## Comments from Industry (I)

2 February 1987

I-1 We have reviewed the draft 1002 Report, particularly those sections dealing with terrestrial biology. Our specific comments are attached. In general, the baseline data collected in ANWR for 1002-related biological studies are of high scientific merit, summarized in a brief (understandably), but informative fashion, and should be of great value in the decision-making process and for assessing development-related impacts. In our opinion, most issues regarding potential impacts have been adequately defined, with the exception of the probability for direct loss of habitats and populations. Sections on "The Effects on the Biological Environment", especially in regard to loss of coastal insect relief for caribou and staging habitat for snow geese, need considerably more support from existing data. At a minimum, more detailed explanations of the criteria and rationale used for estimating habitat loss, amounts of displacement, and population declines are necessary. Without these elements, the impact assessments lack credibility.

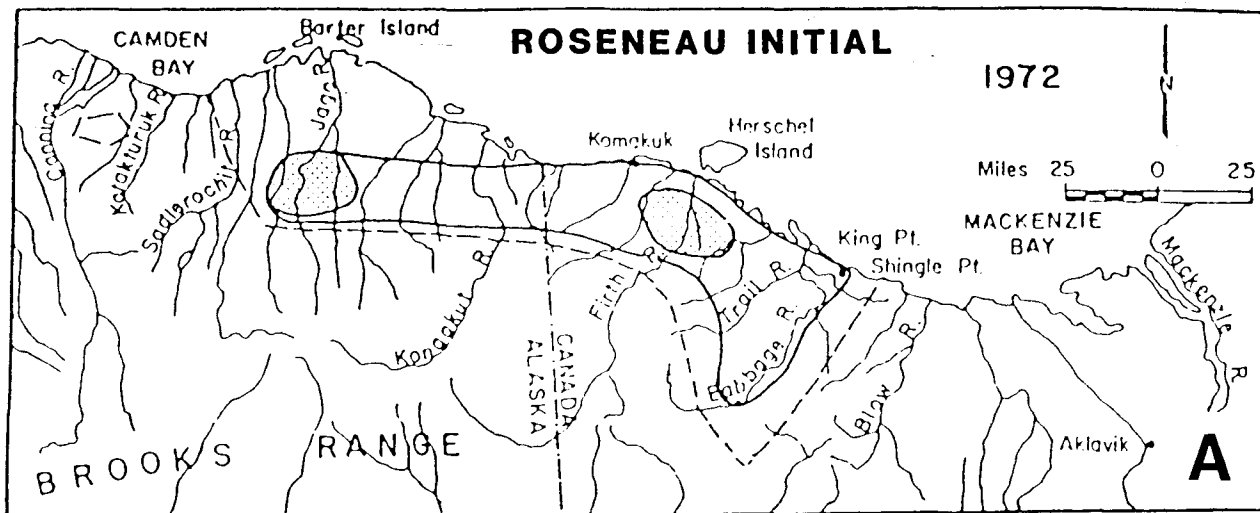
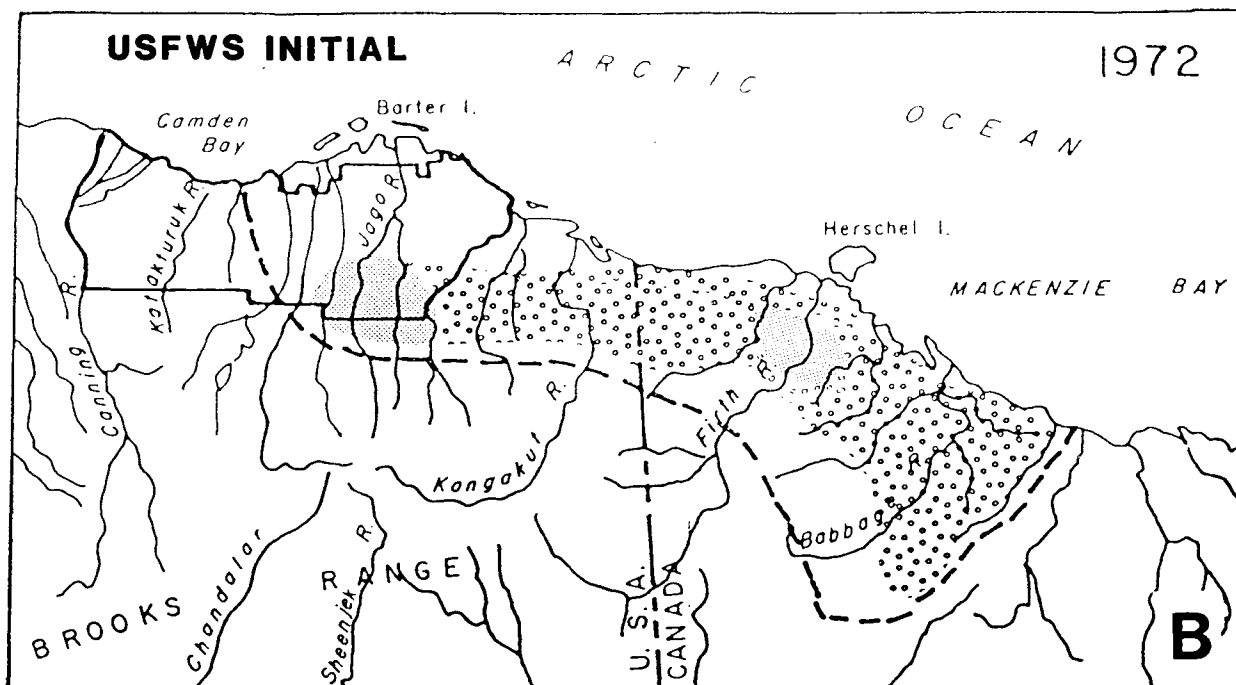
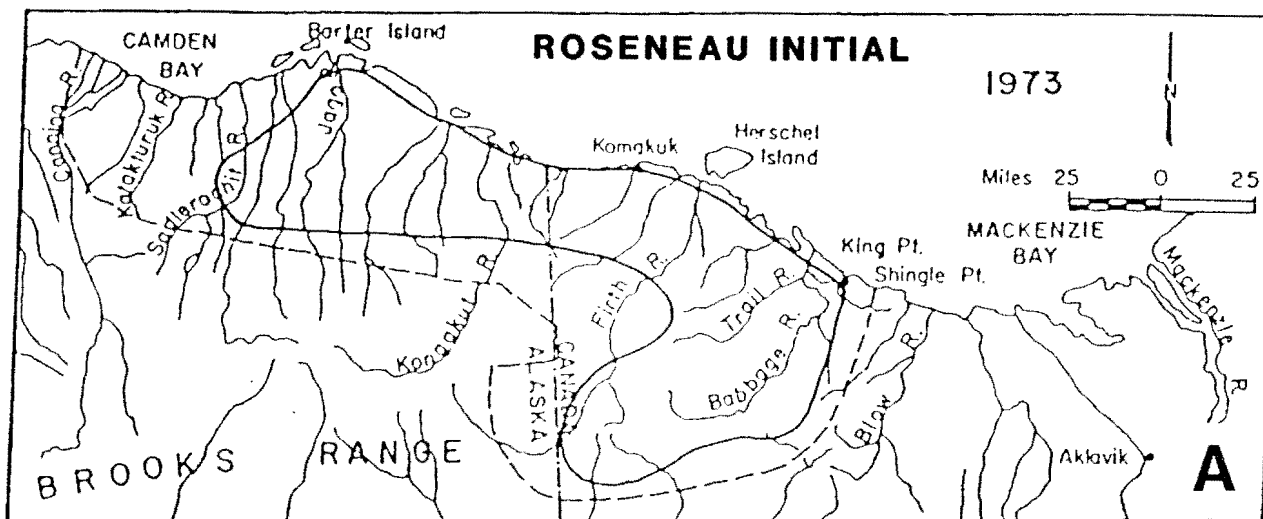
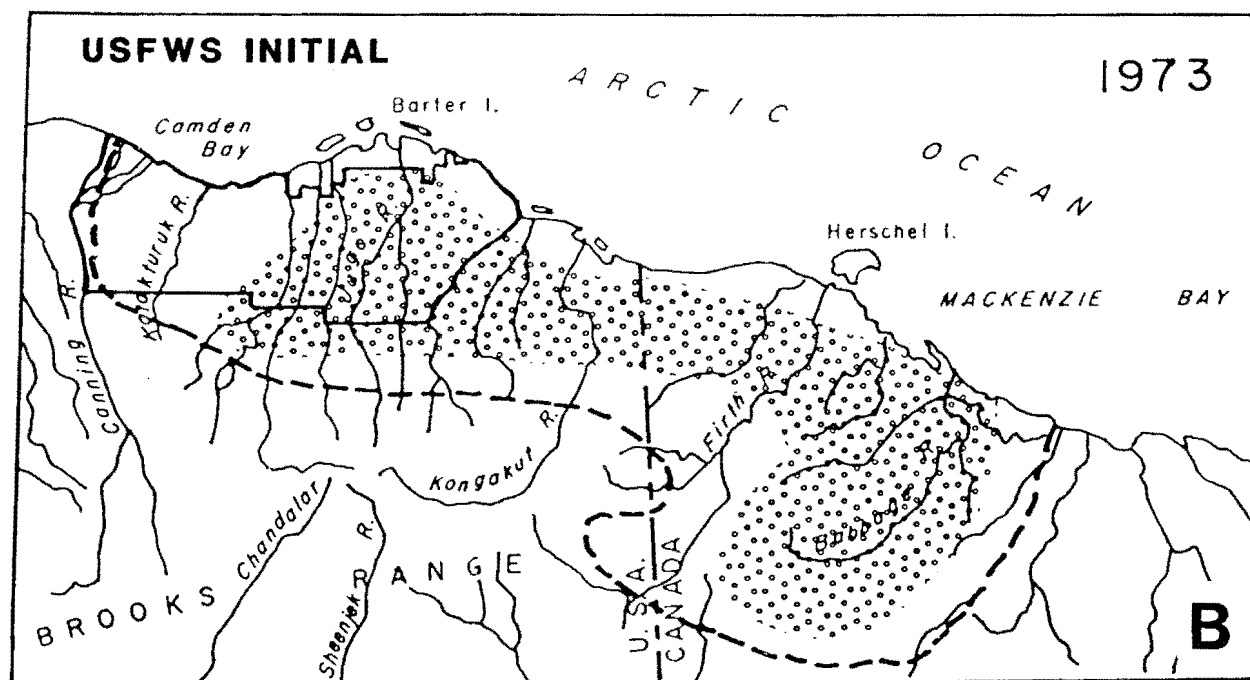
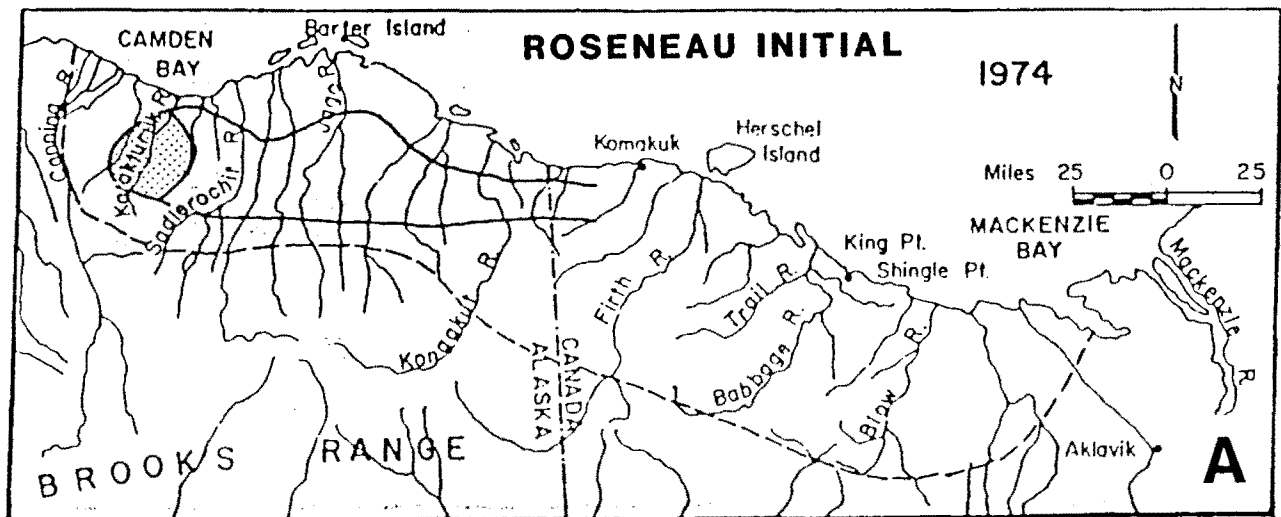
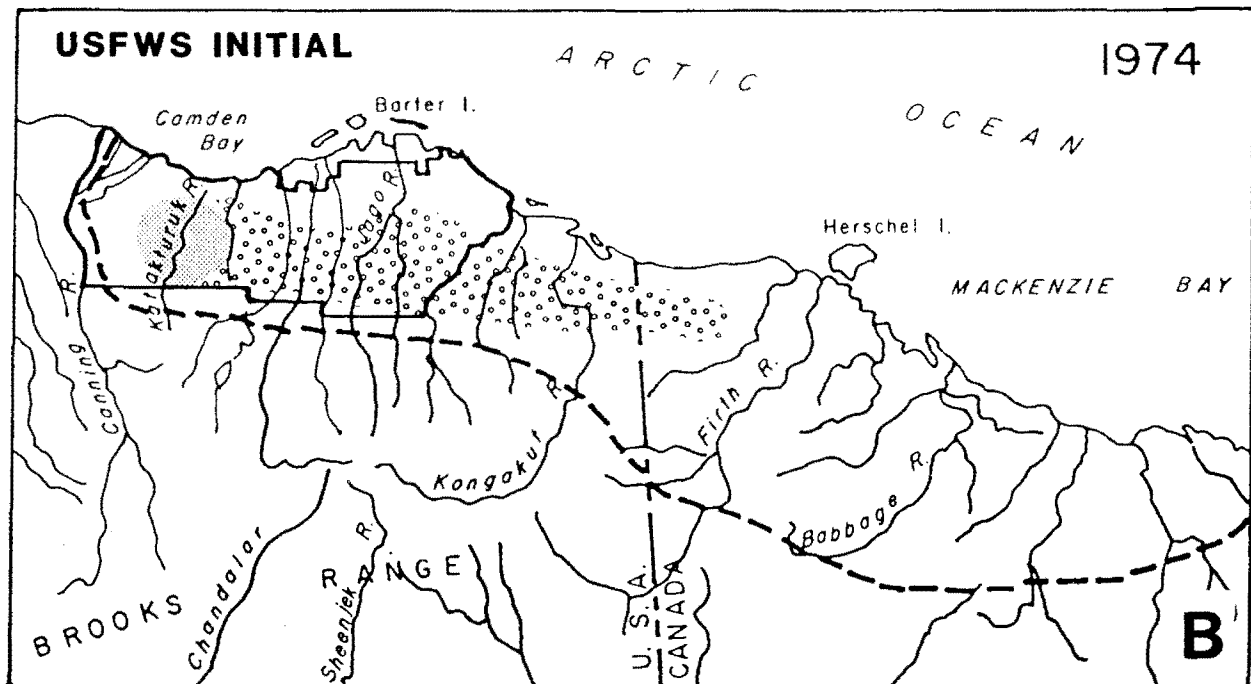
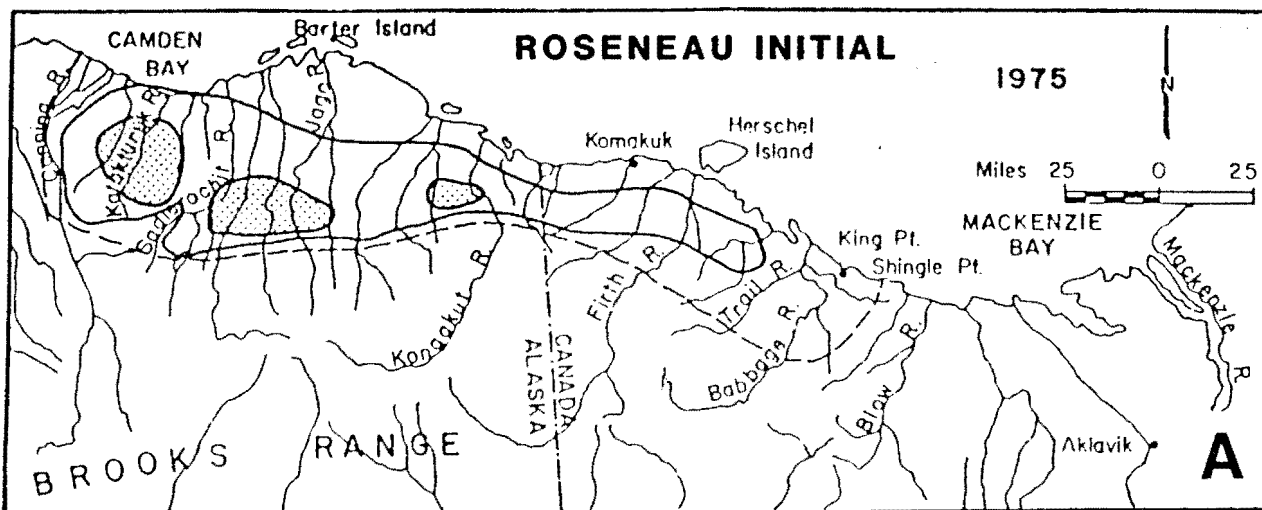
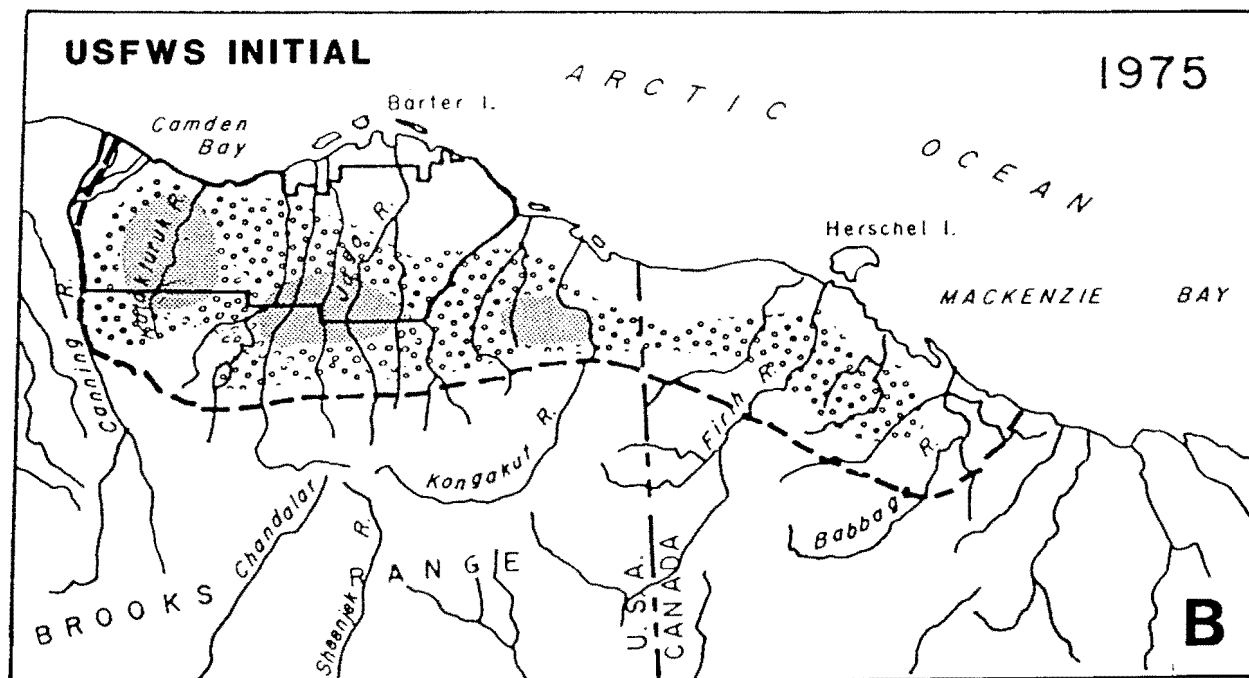
Several problems have been identified with the maps of PCH calving concentration areas shown in Plate 2A. In addition to relatively small plotting errors that can be expected, there are substantial errors that have caused mapped calving areas to become larger in size, to change shape, and to "migrate" (about 16 miles in one case for 1977) (Fig. 3).

We believe that the following sequence of events probably describes what happened during the plotting of the data. First, the original calving concentration maps for 1972-1981 received by FWS from Roseneau (Fig. 3) were enlarged slightly and a base map was drawn, only slightly different from the originals provided. [Note the general similarity in style of the maps. The error of showing the Babbage River flowing directly into Mackenzie Bay rather than into Phillips Bay, the similarity of the representations of the Canning

River delta, and other features suggest a common origin of these maps.] Second, the original data from the Roseneau maps were copied by hand onto the new bases (Fig. 3). A comparison of the two sets of maps will reveal several changes in depicted calving concentration areas, some of the changes large, others small, in all years. Some of the larger changes apparently occurred in the 1977 data. Third, the replotted data were apparently transferred to 1:250,000-scale maps, digitized, and entered into the FWS computer file. Finally, the information was replotted by computer to indicate the degree of overlap and to define the "core calving area" shown in Plate 2A. of the draft report.

With the assistance of D. G. Roseneau, Standard replotted the locations of calving concentration areas using Roseneau's original small-scale maps (Fig. 2). Mr. Roseneau made additional adjustments to make the representations more accurate. We believe that these maps are the most accurate representation of the calving concentrations for 1972-1981. The revised maps have been made available to FWS at a scale of 1:250,000.
